STAFF REPORT

Planning Commission Meeting: April 29, 2024

RZ23-0013: Rezoning from the RP-1 (Planned Single-Family

Plan for Caribou Coffee

CONCEPT SITE PLAN
SQ. FOOTAGE: 605 SF
INTERIOR SEAT COUNT: NONE
EXTERIOR SEAT COUNT: 16 SEATS
REVISED: APRIL 22, 2024

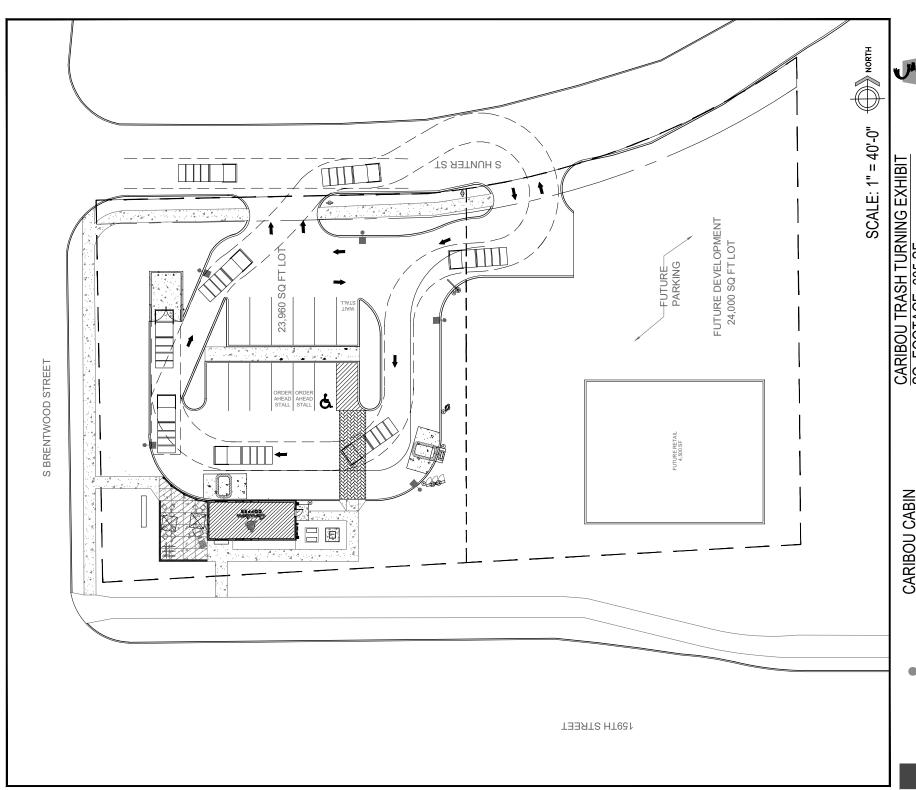
- a. <u>Access/Streets</u> The proposal takes full access from Hunter Street, and a new sidewalk will be installed along Hunter Street connecting to Brentwood to the west and extending to the approved development to the east. Access for the conceptual commercial lot will be reviewed with a revised preliminary site development plan when a future use and tenant has been identified. Revised access and traffic circulation for Lot 1 will be forthcoming with the final site development plan if recommended for approval as stipulated.

- b. <u>Drive-Through</u> A single lane drive-through for the coffee shop is proposed to the north and east of the coffee shop. The drive-through provides over 188 feet of stacking length from the drive-through entrance to the menu board, exceeding the minimum requirement of 80-feet. In addition, a future escape lane is shown and may be installed if desired by a future tenant.

- c. <u>Parking</u> A parking analysis is required for the proposed drive-thru use as no indoor seating is provided for customers. The development includes 12 on-site parking spaces to provide parking for up to five (5) employees during peak shifts. A wait stall for drive thru orders has been included and six (6) stalls for general customer use to accommodate the outdoor seating area and walk-up order window that is a separate pedestrian-oriented feature from the drive-thru. Caribou's prototype for the smaller cabin coffee shop concept, typically requires 15 total stalls, so the proposed parking represents a reduction in parking relative to current prototypical corporate standards. Further, the proposal does not exceed 125% of the minimum parking as required by the C-1 District.

- b. <u>Street Frontage Area</u> The proposed buildings are setback 15-feet from W. 159th Street and occupies over 30% of the street frontage length, which complies with the street frontage area requirement along W. 159th Street.

- c. <u>Parking Pod Size</u> The proposal includes 12 stalls in the largest parking pod, which complies with the maximum of 40 stalls per parking pod.
- d. <u>Pedestrian Connectivity</u> At least two prescribed pedestrian connections options must be provided on site. The site provides decorative crosswalks within the development, a new sidewalk will be constructed along Hunter and Brentwood streets, and connections are provided to Brentwood and to the existing sidewalk along W. 159th. The pedestrian gateway option is also met by the well-landscaped outdoor patio with a limestone wall feature at the pedestrian entrances off Brentwood and W. 159th streets.

- A waiver is granted from UDO 18.20.130.B to decrease the minimum front yard setback from 20-feet to 15-feet and to reduce the minimum frontage buildout from 50% to 30% along 159th Street as shown on the preliminary site development plan dated April 1, 2024.

- 3. A revised preliminary site development plan is required for Lot 2 prior to submittal of a final site development plan.
- 4. Revised access and traffic circulation for Lot 1 will be provided with final site development plans as required by the City Engineer.

CONCEPT LANDSCAPE PLAN
SQ. FOOTAGE: 605 SF
INTERIOR SEAT COUNT: NONE
EXTERIOR SEAT COUNT: 16 SEATS
REVISED: APRIL 22, 2024

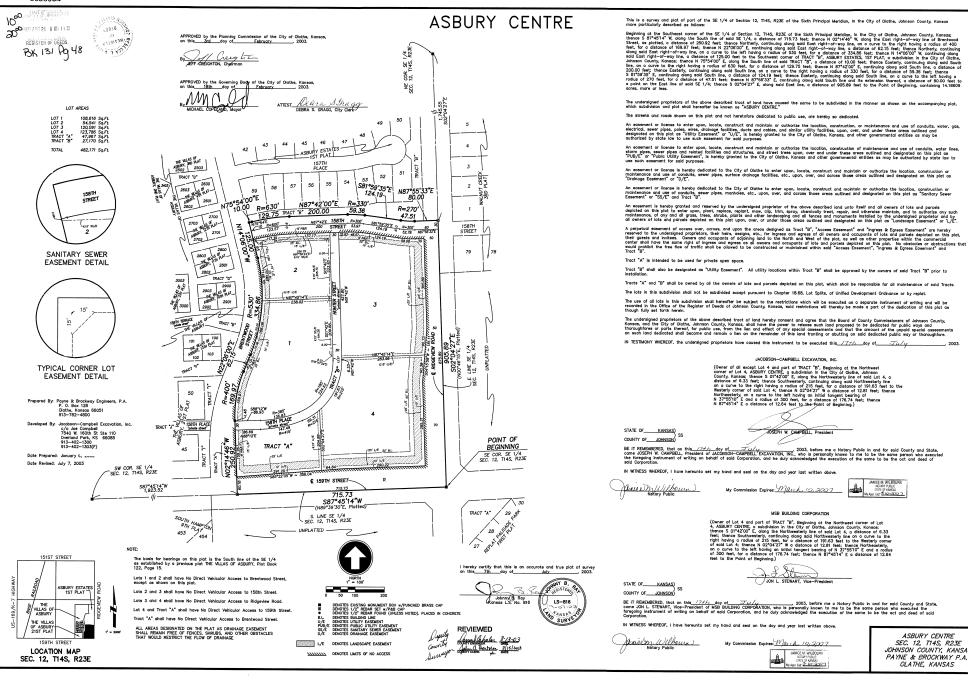
- d. <u>Landscaping/Screening</u> The proposed development exceeds all landscape requirements. Along the perimeter of the site, the required plantings are proposed along all street frontages and buffer requirements are met along the abutting properties.

Internally, the proposed parking lot and building foundation landscaping exceeds UDO requirements.

All building mounted utilities, and all ground- and wall-mounted utilities will be adequately screened by the proposed landscaping. A brick trash enclosure is proposed along the west side of the development that will be adequately screened.

- a. <u>Landscape Options</u> One of the prescribed landscape options must be provided where building façades are not located in the minimum frontage. The development provides the planted buffer with a two- to three-foot-tall limestone wall along 159th Street.
